RE: MERIDIAN ENERGY LIMITED (MEL) – APP.045356.01.01 – LU2300093 – RFI RESPONSE No# 2

Civil and Flooding Responses to S92

The recent consent application in support for the Ruakaka Solar Energy Park attracted comments under the provisions in section 92 of the RMA. Below are the comments received and responses to each of those comments.

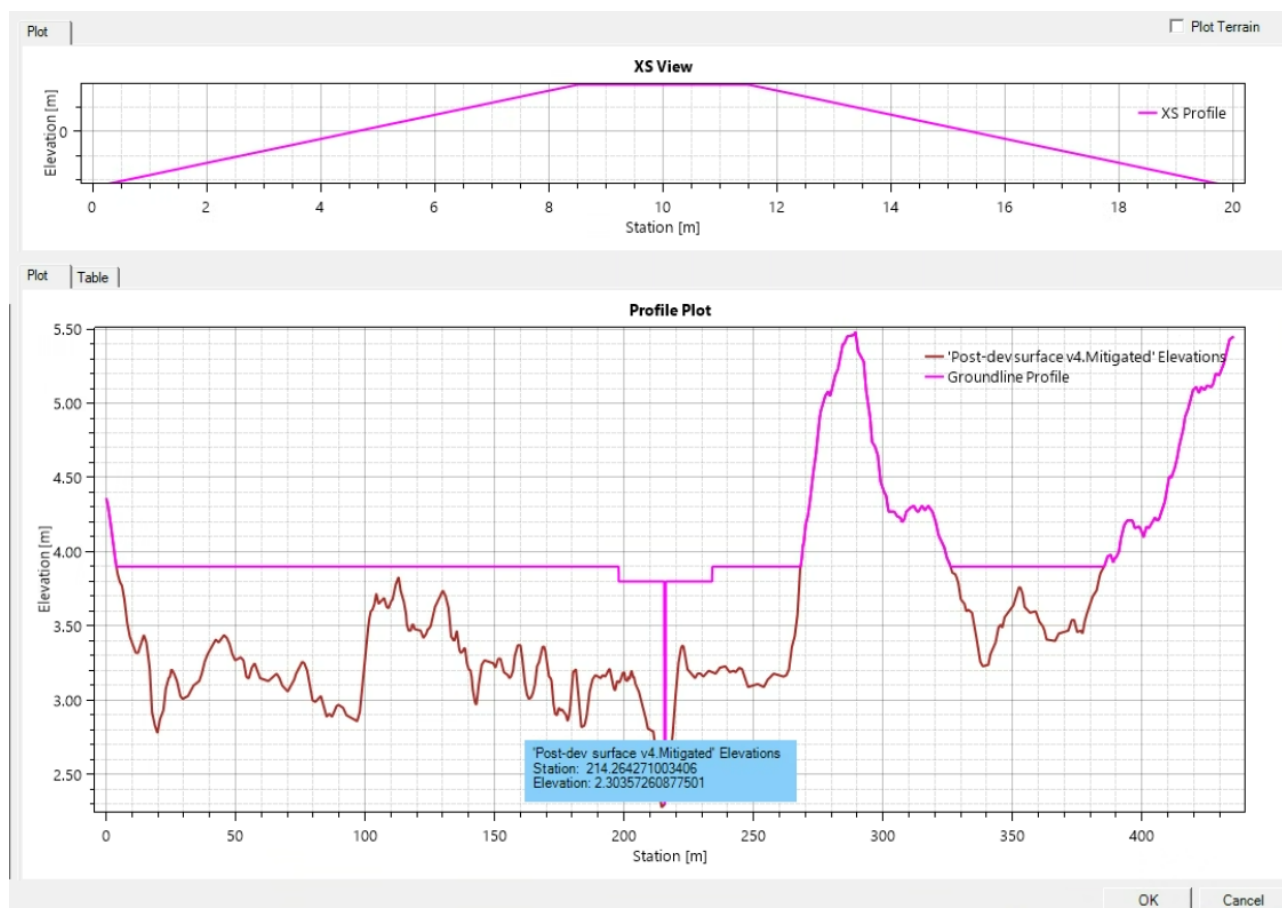
SITE 1: No impact is achieved via a bund with outlet structures along the downstream (north-eastern) boundary but little detail is provided in terms of what the bunds/outlets would look like.

- a. We note there are little details on these assets provided in the flood modelling report. Given they are critical in protecting downstream properties, it would be good to see. They may be included in the Civil Design Report (Beca).
- b. Consideration of maintenance would be important too, dependent on height of bund.
- c. Details can likely be addressed at the detailed design stage. However, modelling will be needed to confirm that there is no detrimental impacts off-site.

Beca Response to 2a

A bund is shown on the civil drawings with the note and line type shown in in the circled area as a clip shown below. This bund was specifically sized for the earthworks profile modelled for the site. If the earthworks

profile changes, the bund will need to change. Similarly, if the imperviousness of the site changes, this bund can be modified to hold water back to achieve a neutral flood effect.

To maintain flexibility in design and still consent the project, a condition is proposed to be added to the consent that addresses the flood effects as a result of the earthworks, surface roughness and impervious surfaces changes in combination. This consent condition may read:

“The consent holder shall achieve a flood level increase of not more than 5mm on any land outside the project site in the 100 year ARI rainfall event. This shall be demonstrated using a hydraulic model and submitted to Council and approved 40 days prior to construction commencement. The flood model shall take earthworks, ground roughness and soil infiltration changes into account. Soil infiltration changes shall be calculated using the PV-SMaRT Solar Farm Runoff Calculator Version 3.0 tool from the University of Minnesota”
